RESPONSE TO REQUIREMENT NOTICE – SECTION 44, REGIONAL PLANNING INTERESTS ACT 2014 – REGIONAL INTERESTS DEVELOPMENT APPROVAL – THOMSON RIVER WEIR PROJECT – LOT 2 SP123565 & LOT 4 SP232181 (DHLGPPW Ref: D24/16158; Our Ref: 2023-111)

Re: Thomson River Weir Raising Project – RIDA Requirement Notice Response

RPI24/030: Longreach Regional Council -Thomson River Weir Project

Attachment D – Thomson River discharge plots

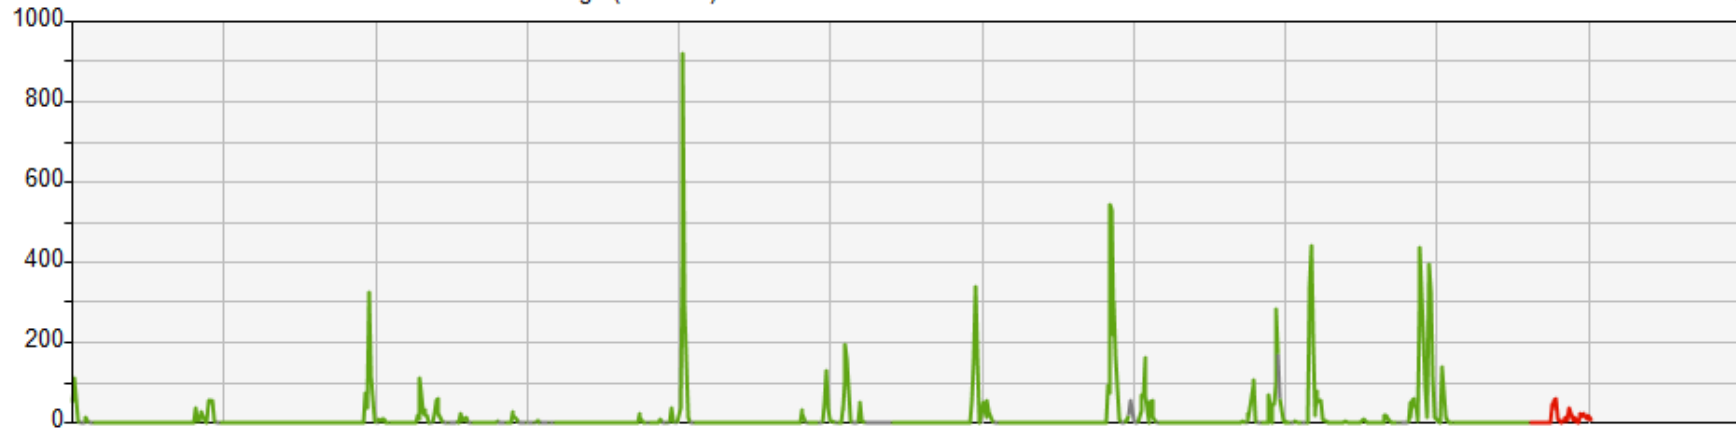
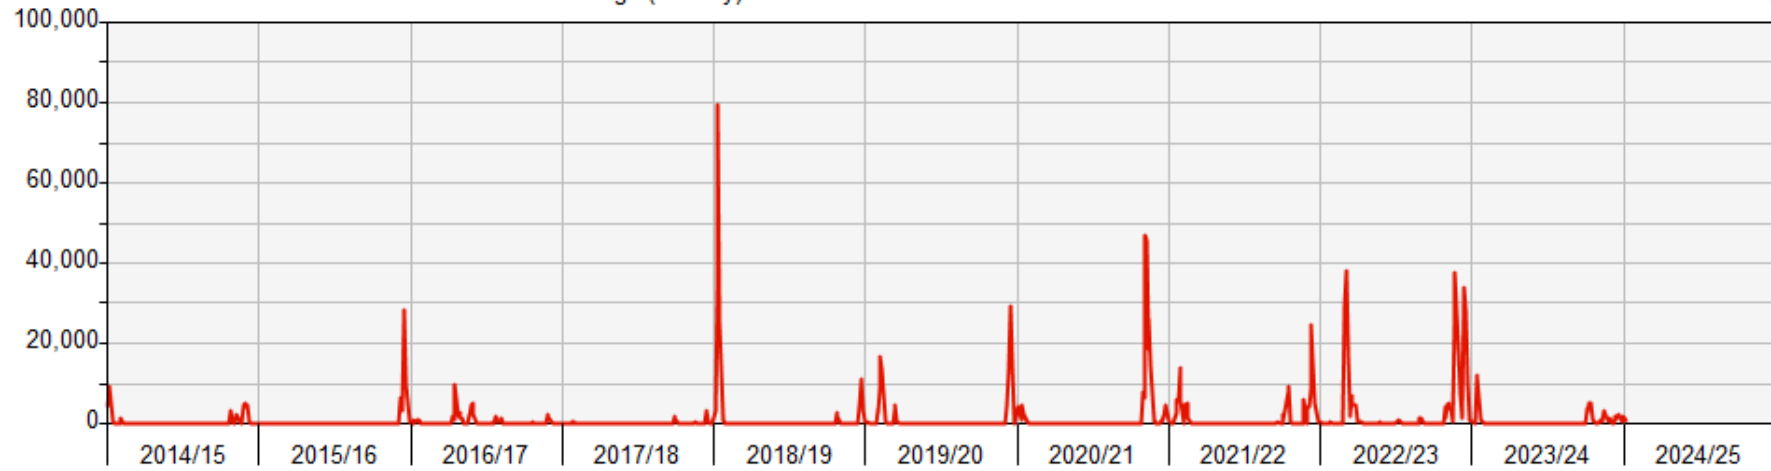
<p>2. <u>Actions:</u></p> <p>Provide additional information comparing the current situation with the proposed situation in regard to the change in the number of ‘no-flow’ days and ‘low flow’ days past the Longreach Weir. As guidance, the Cooper Creek Resource Operations Plan Nov 2013 describes a low flow as a flow of less than 100ML/day.</p>	<p>Attachment D provides discharge plots for the Thomson River gauging station at Longreach (003202A), obtained from the Department of Regional Development, Manufacturing and Water (DRDMW) <i>Water Monitoring Information Portal</i> (WMIP).</p> <p>The plot shows that for the majority of the time, there is less than 100 ML/day of flow occurring, with periodic spikes during rainfall periods. This discharge pattern is characteristic of the distinct dry and wet seasons in northern and western Queensland, and the perennial nature of the Thomson River.</p> <p>An analysis of the daily flow data downloaded from the WMIP indicates that out of 20,013 days of record since May 1969, no-flow has been recorded at the gauge on</p>

Issue	Response
	<p>12,232 days (61%), with low flow (<100 ML/day) occurring on 2,579 days (13%). Importantly however:</p> <ul style="list-style-type: none"> • Mean daily discharge volume recorded for flow days (>0 ML/day) was 7,426.49 ML/day • Mean daily discharge exceeded 900 ML (i.e. the additional storage volume provided by the Project) on 38% of flow days • Discharge volumes for each 'flow event' (i.e. periods where flow was recorded for consecutive days, with no-flow days at the start and end) exceeded 900 ML (i.e. the additional storage amount due to the Project) in 74.6% of events, and flow during these periods averaged 5,192.7 ML/day. <p>Although the Project may increase the number of flow events where the weirs would not be overtopped, it should be emphasised that the Project includes provision of fish passage on the Town Weir, an improvement on the existing case.</p> <p>Based on the above, the Project would not have a discernible impact on the number of no-to-low flow days downstream on the Thomson River, which already experiences no-to-low flow 74% of the time.</p>

Attachment E – Thomson River temperature and EC plots

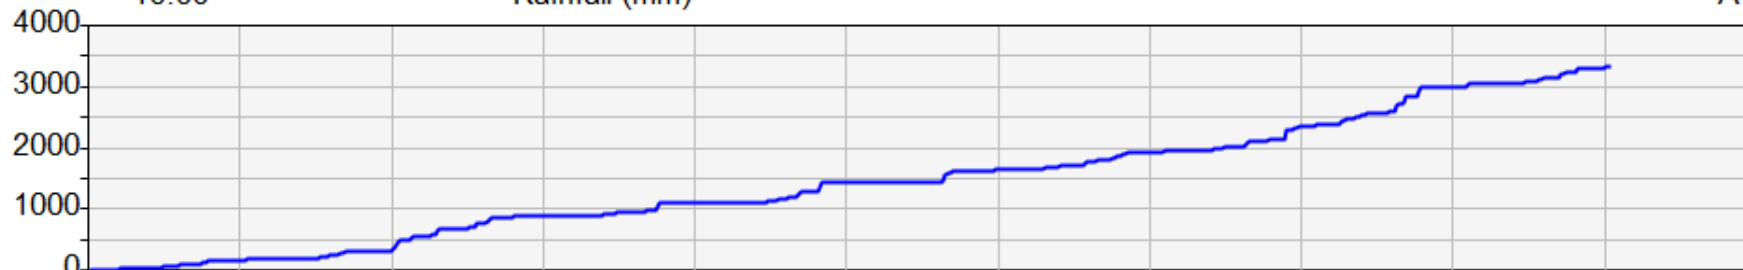
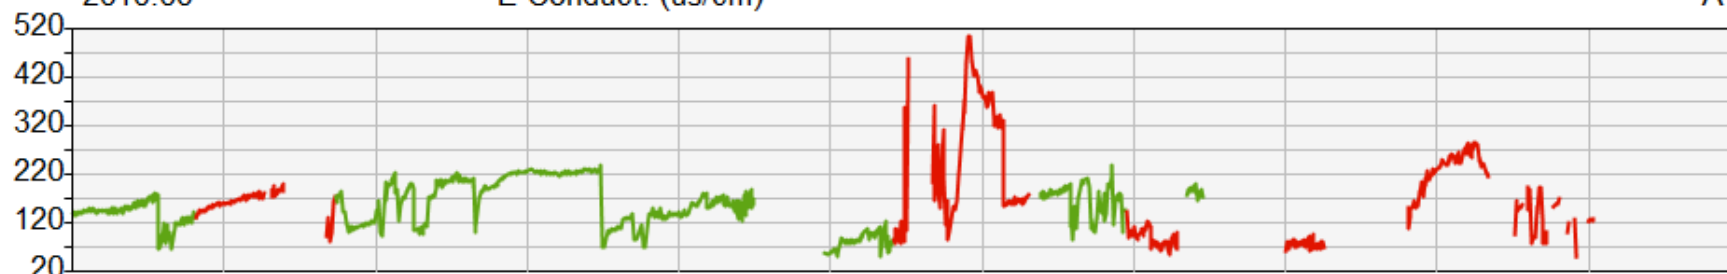
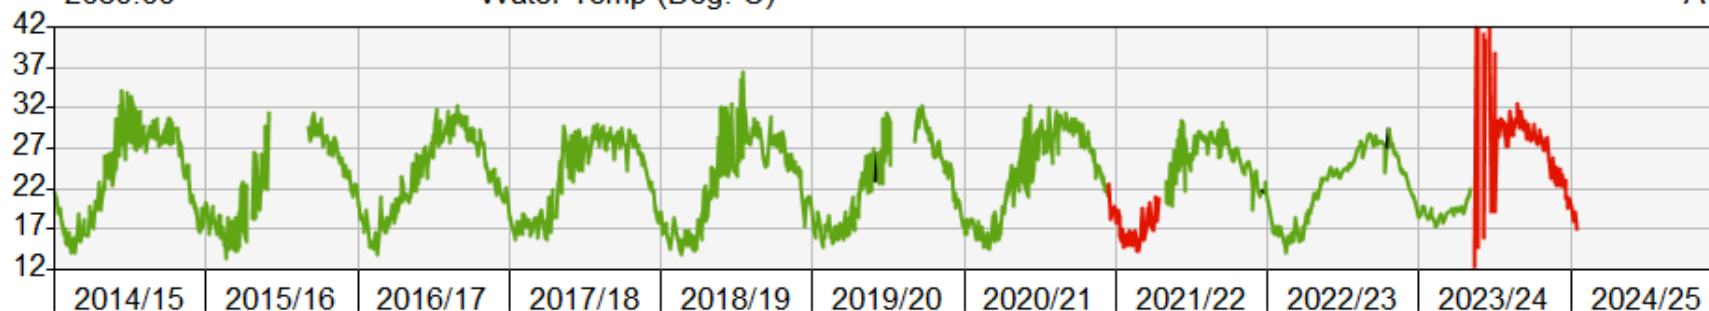
5.	<p><u>Issue:</u></p> <p>Background water quality in the study area was characterised by taking grab samples of water from a range of sites, within and up and downstream of the proposed weir plus an additional location outside the weir area. While the site locations appear suitable, the study provides a snapshot only and relies on a single sample at each site to describe water quality. Additional sampling data is needed to describe potential variation in water quality such as across seasons (wet and dry).</p> <p>All available water quality data should be described and summarised. Water quality data from Water Monitoring Information Portal was not included in the desktop search. An example is the site 003202A Thomson River water level at Longreach. Only flow data appears to have been considered and not water quality for this site. Additionally, if the Longreach Regional Council hold water quality data on the existing weir, this data should be included in the baseline study.</p> <p><u>Actions:</u></p> <p>Provide:</p> <p>(a) a review and analysis of existing water quality data held by the Queensland government and Longreach Regional Council, where available</p> <p>(b) additional sampling data obtained from field sampling and/or desktop review, to adequately characterise water quality across seasons (wet and dry)</p> <p>(c) information considering relevant Environmental Values and guidelines, including human and stock drinking water quality guidelines all constituents, with reference to water quality. It is noted that human and stock drinking water guidelines require analysis of total metal concentrations.</p>

5. <i>Actions:</i> <i>Provide:</i>	Electrical conductivity (EC) and temperature are monitored at the Thomson River at Longreach station (003202A) and are available on the Queensland Water Monitoring Information Portal (WMIP). Attachment E provides EC and temperature results obtained

Issue	Response
<p>(a) <i>a review and analysis of existing water quality data held by the Queensland government and Longreach Regional Council, where available</i></p>	<p>from the station 003202A from 2024 to 2024. When compared to the sampling results obtained by NGH for the Project in July/August 2023:</p> <ul style="list-style-type: none"> • Mean temperature recorded across the Town Weir sites was 17.6°C. Mean temperatures in the WMIP for July/August is 16.8°C. • Mean EC recorded across the Town Weir sites was 160.8 µs/cm. Mean temperatures in the WMIP for July/August is 161.6 µs/cm. <p>Analysis of the publicly available water from the WMIP shows good correlation with the samples taken by NGH.</p>
<p>(b) <i>additional sampling data obtained from field sampling and/or desktop review, to adequately characterise water quality across seasons (wet and dry)</i></p>	<p>The water quality samples collected during the aquatic ecology field survey (Appendix E) were obtained during the dry season. It is considered these samples are sufficient for determining background water quality, given:</p> <ul style="list-style-type: none"> • Dry season samples are considered conservative when compared to wet season samples; that is, accumulation of physio-chemical stressors and toxicants is more likely to occur during the dry season given the perennial nature of the Thomson River. Concentrations of these parameters are more likely to be diluted during the wet season due to flushing from seasonal heavy rainfall. • Project construction will occur primarily during the dry season to avoid potential inundation (and associated risk of water quality impacts). • Additional sampling and characterisation of the background water quality within the Thomson River throughout would not assist in assessing the potential impacts of the Project. <p>Notwithstanding the above, additional desktop data has been downloaded from the Queensland Government WMIP, see responses to 5(b) above.</p>
